**FINAL  
TECHNICAL MEMORANDUM No.2**

**ADDENDUM TO FINAL PHASE I  
RFI/RI WORK PLAN**

Rocky Flats Plant  
Woman Creek Priority Drainage

(Operable Unit No. 5)

**EG&G** **FIGURE 22**

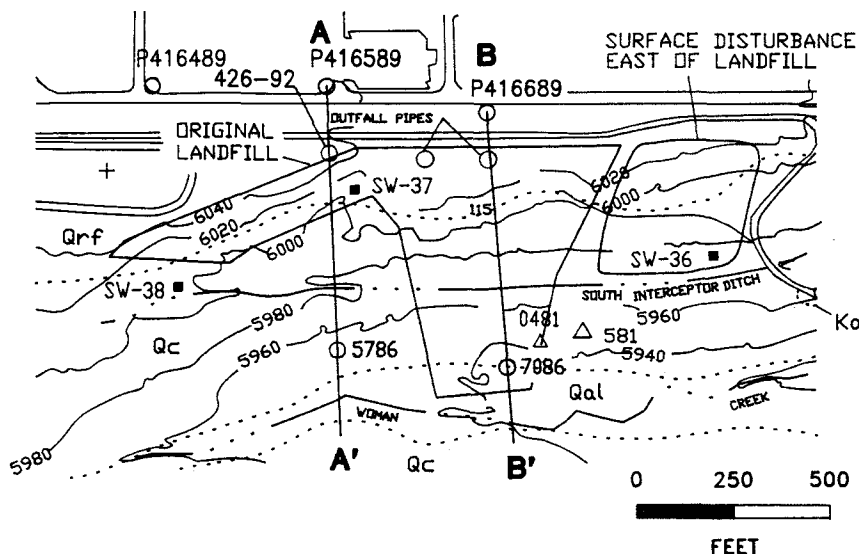
Item	Comment(s)	Disposition
Section 2.1.1, Page 7, Second Paragraph.	Because the area of the landfill was not geologically mapped before dumping began, and has not been drilled through, any cross sections are speculative. Therefore, the presence of permeable alluvium or colluvium, or the lithology of the Arapahoe formation underlying the landfill is currently speculative also. Analysis of the dip angle and trends of the Arapahoe number 3, 4, and 5 sandstones indicate the possibility that one or more of these relatively permeable lithologies subcrop (underlie) the landfill. If this is the case, leachate flow could take a different direction than stated. This section should recognize this possibility.	Bore hole 426-92 was drilled north and adjacent to the Original Landfill in 1992. It was drilled to a depth of 158 feet, and is added to cross section A-A' in TM2. This hole confirms the lithology and stratigraphy originally shown on the cross section, and confirms that the landfill is underlain by claystones of the Arapahoe Formation. Because of lost core intervals, it could not be fully determined from the lithologic logs if some Arapahoe Sandstone intervals could exist in the bore hole. Annetta Primerose of EG&G/RFP confirmed (October 1, 1992) that the electric logs of hole 426-92 indicated that the entire interval below the unconformity/bedrock contact consists entirely of claystone. The information provided in the cross sections is valid.

FIGURE 2.7

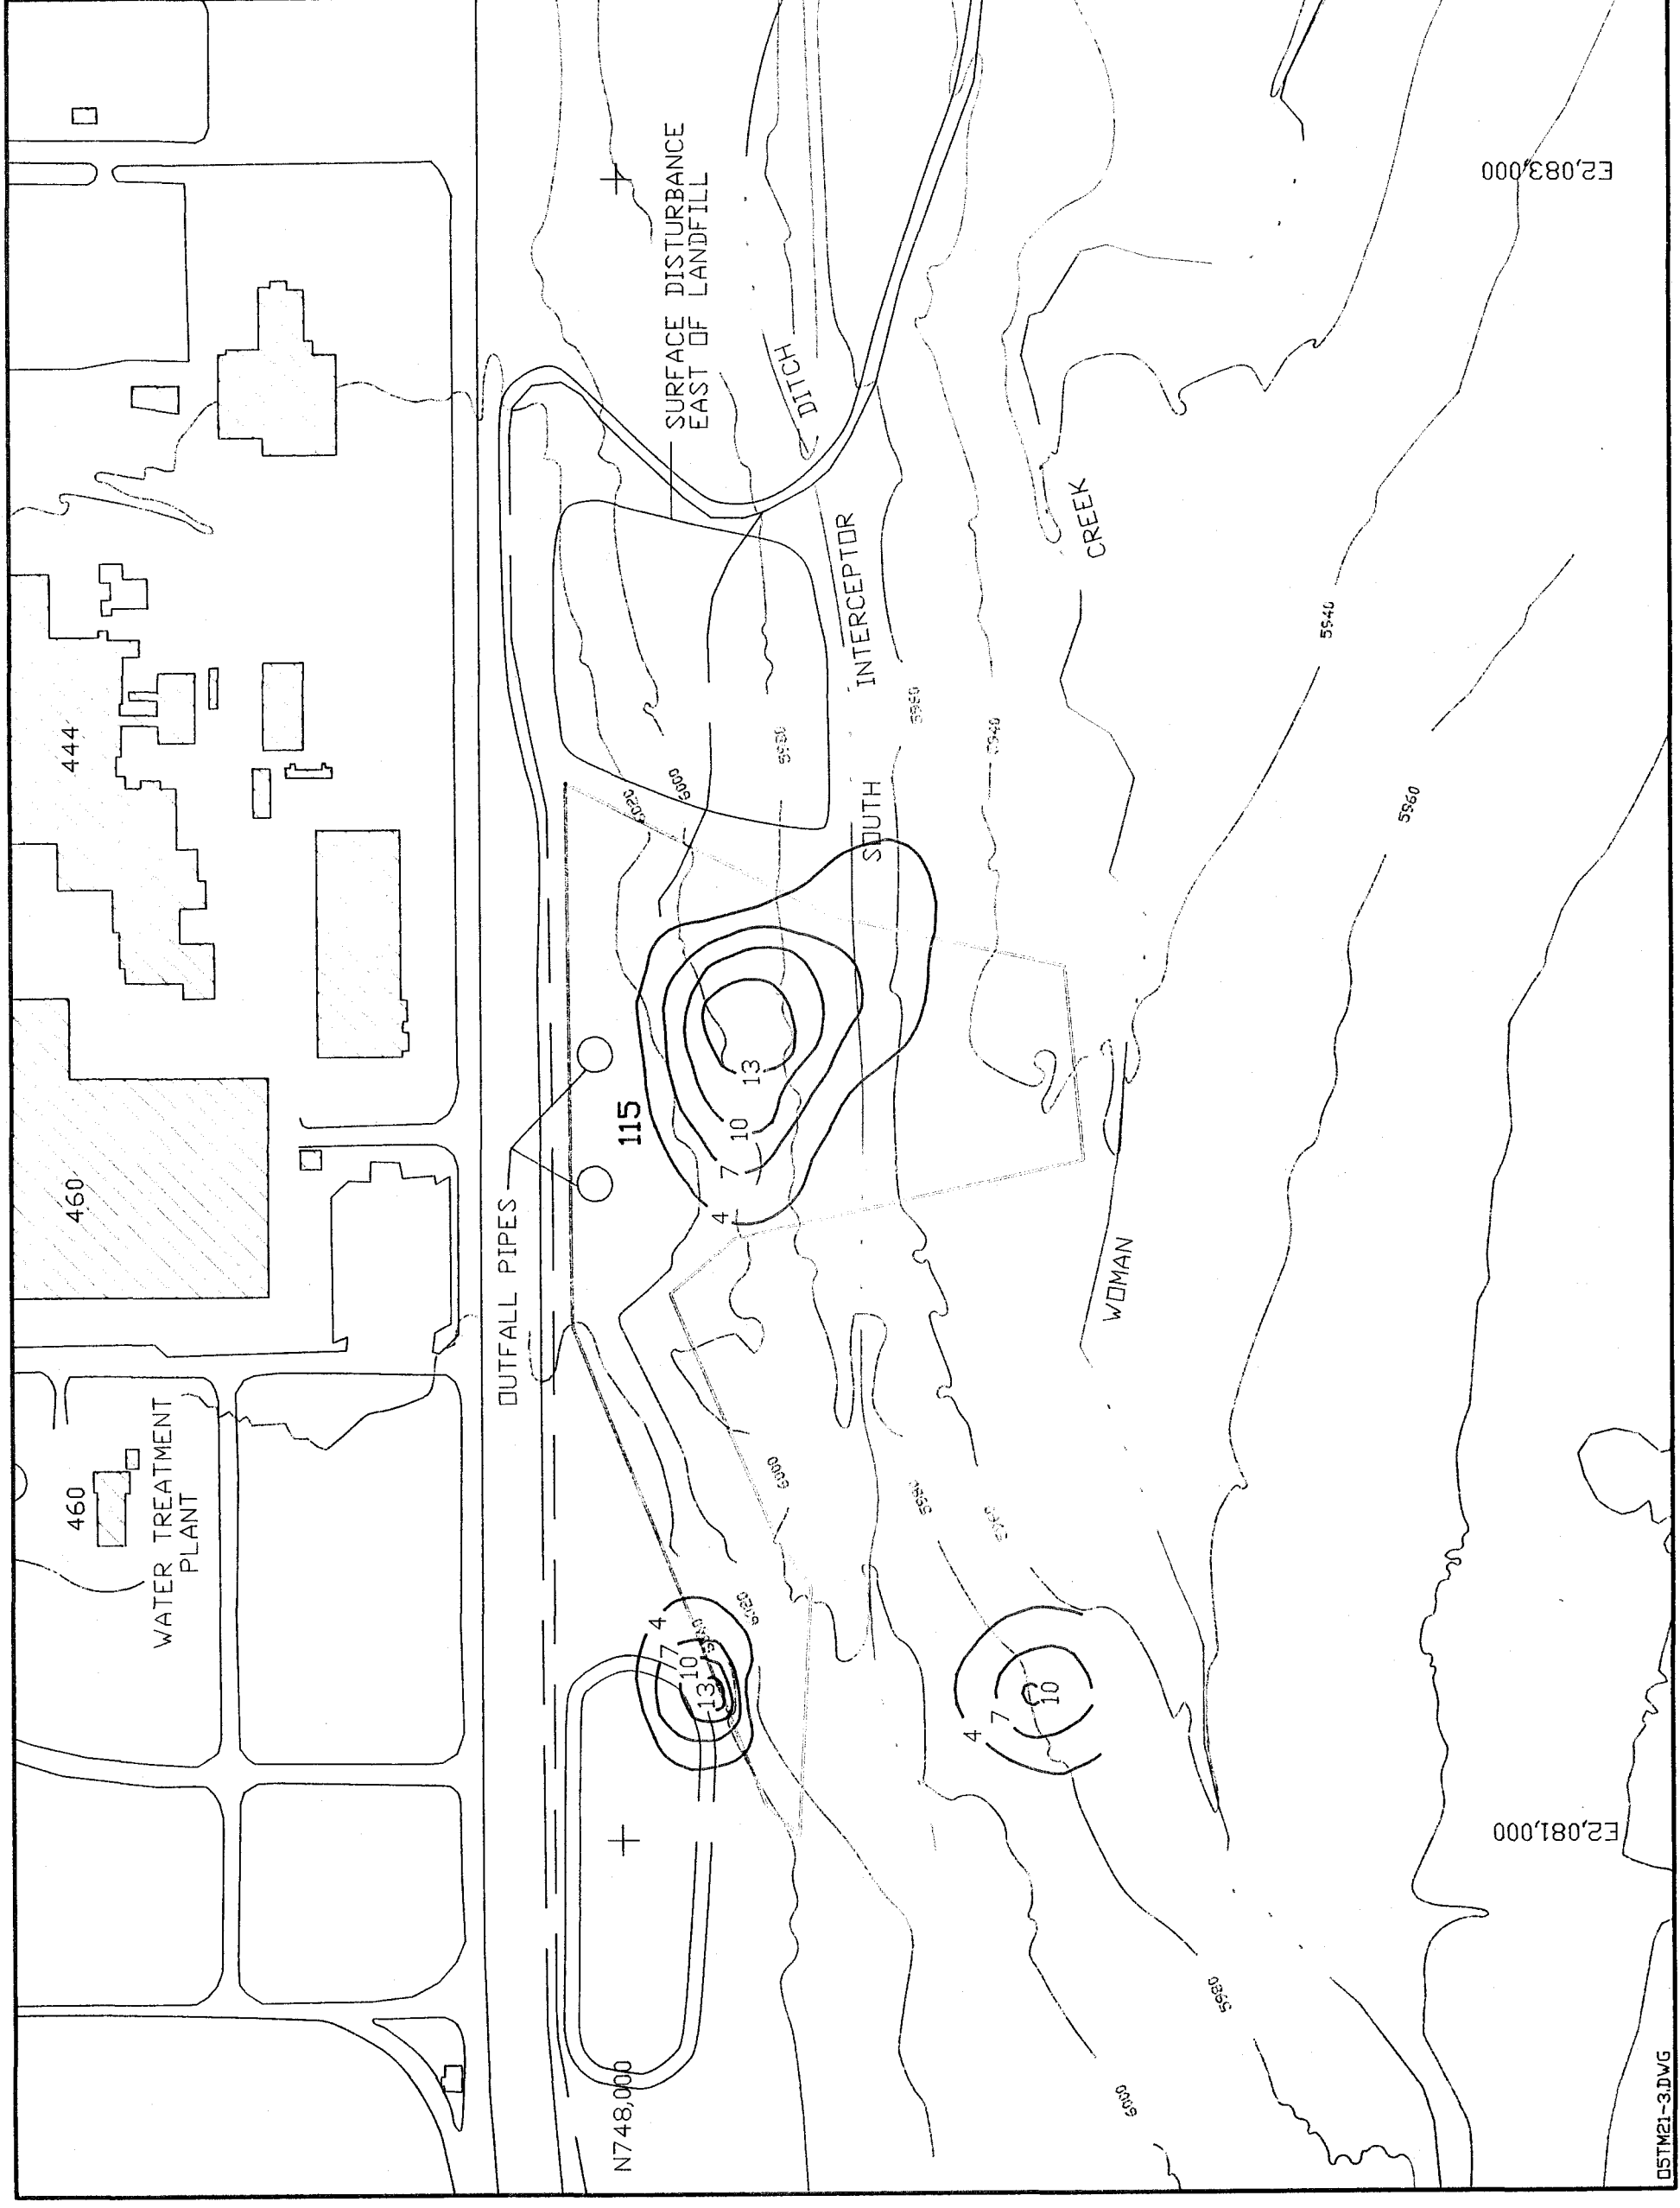
Item	Comment(s)	Disposition
Figure 2.7	The oblique aerial photo included as Figure 2.7 should have a date indicated on the photo label.	The photograph used in Figure 2.7 is provided with the date of June 6.
General	An HPGe radiation survey is planned for the ash pits area covering the same area that will be geophysically surveyed. We recommend that the HPGe survey precede the geophysical surveys.	This general comment restates the task work prioritization for Stage 2 screening specified in the OU5 RFI/RI Work Plan, Phase I Field Sampling Plan, dated February 1992. A statement so indicating this directive for the Ash Pits has been added to Section 2.1.3 indicating this part of the site assessment task sequence.
